Assessment against planning controls: section 4.15, summary assessment and variations to standards

1.1 Section 4.15 'Heads of Consideration'

Figure 1: Grey white areas highlight non-compliant areas

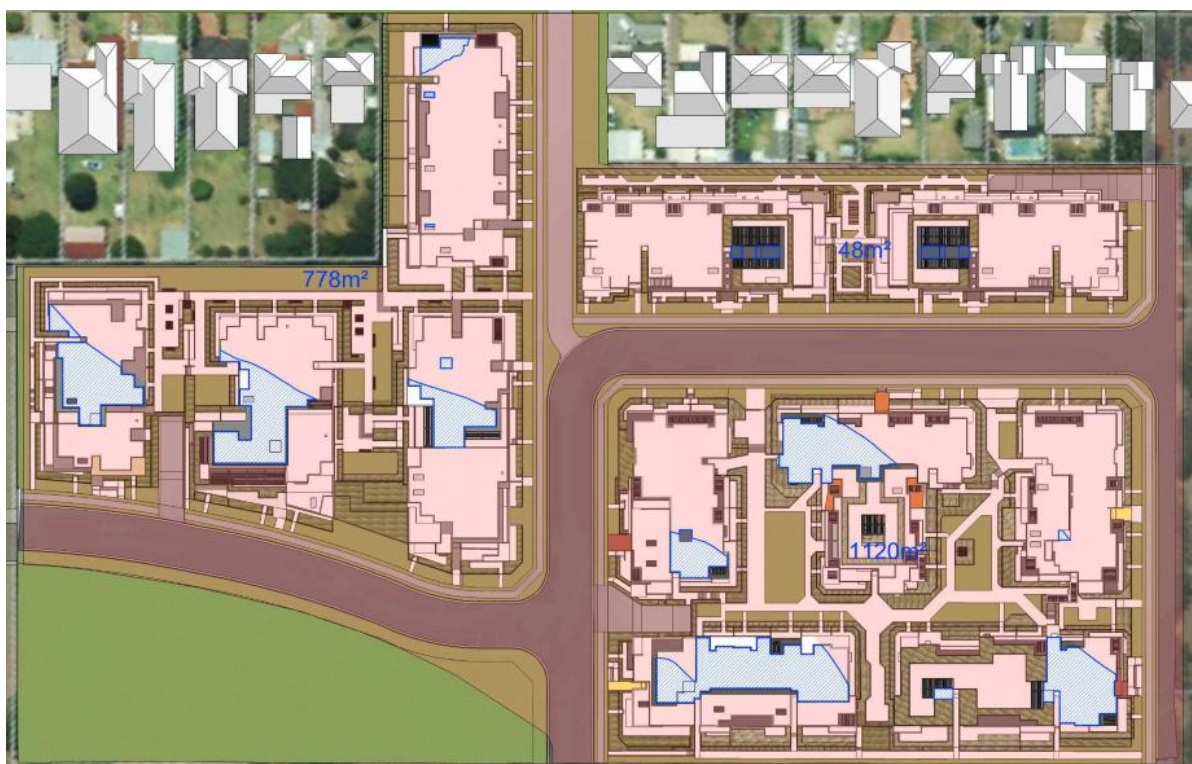
- 1.3 The development seeks a height variation of between 500mm and 2.6m to the top of the roof/overrun for some buildings. The variation to Buildings B & C relate to the access to the communal roof top open space.
- 1.4 The following diagram illustrates the areas of non-compliance across the development site:

- 1.5 A maximum building footprint of 1946m² will exceed the 16m height control by varying degrees as shown in Table 1 above. This equates to a total of 17.8% of the proposed building footprint.
- 1.6 Overall, 82.2% of the proposed building footprint fully complies and is below the maximum 16m LEP height control limit.
- 1.7 The report is structured to address the requirements of Clause 4.6 using the following headings:
 - What is the variation to the standard?
 - Is the development consistent with Objectives of the zone.
 - Is the development consistent with the objectives of the standard?
 - Is compliance with the development standard unreasonable and unnecessary in the circumstances of the site? 4.6(3)(a) and 4(a)(i)
 - Are there sufficient environmental planning grounds to justify the contravention of the development standard?

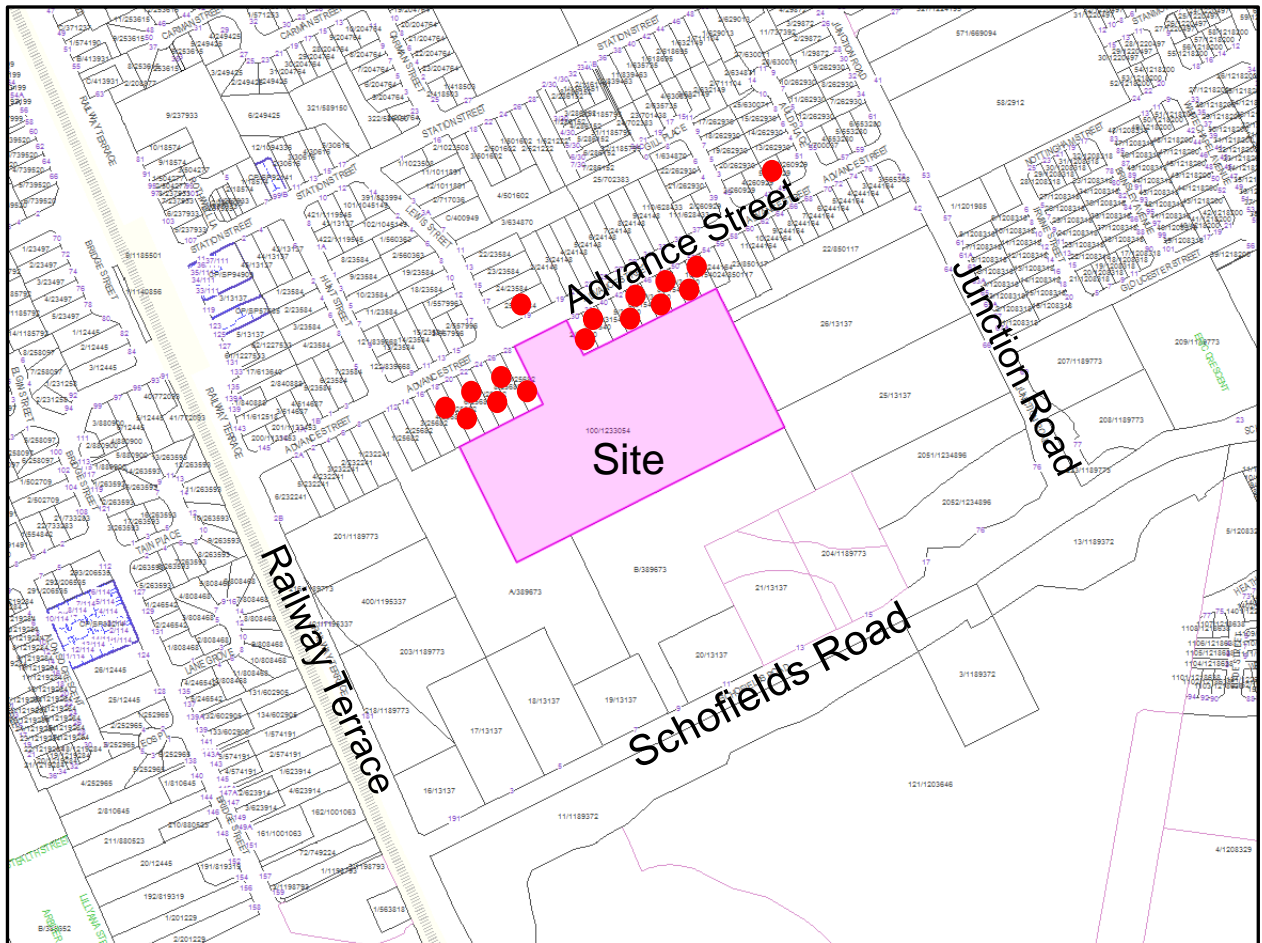
Several properties located along Advance Street have raised concerns that the deletion of the Indicative Layout Plan road south of their properties will be a poor outcome and result in the loss of a buffer space and building separation, decreased privacy leading to devaluation of property prices, and reduced redevelopment potential of properties along Advance Street which will only have street frontage available to Advance Street. Concern was also raised with regard to loss of enjoyment of the use of their land and privacy, impact on traffic volume and safety on Advance Street, necessary infrastructure is not in place and will worsen with large developments, noise from occupants of the apartments and air conditioning units, impacts on the existing services such as water pressure and drainage as the site slopes downwards towards Advance Street, and loss of pedestrian pathways.

| Issue | Applicant's response | Planning comment/response |
|--|--|--|
| 1) Inadequate and inaccurate analysis of available road access servicing development. | <p>The revised drawings submitted to Council in October 2017 outline the proposed Indicative Layout Plan (ILP) changes and the increase in developable area.</p> <p>The amended drawings and accompanying documentation demonstrate that the development can function with the reduced roads and will not affect future redevelopment potential of properties along Advance Street as the original ILP did not provide direct access for the Advance Street properties.</p> | The Applicant's revised submission clearly shows the proposed road network. Refer to attachment 5. |
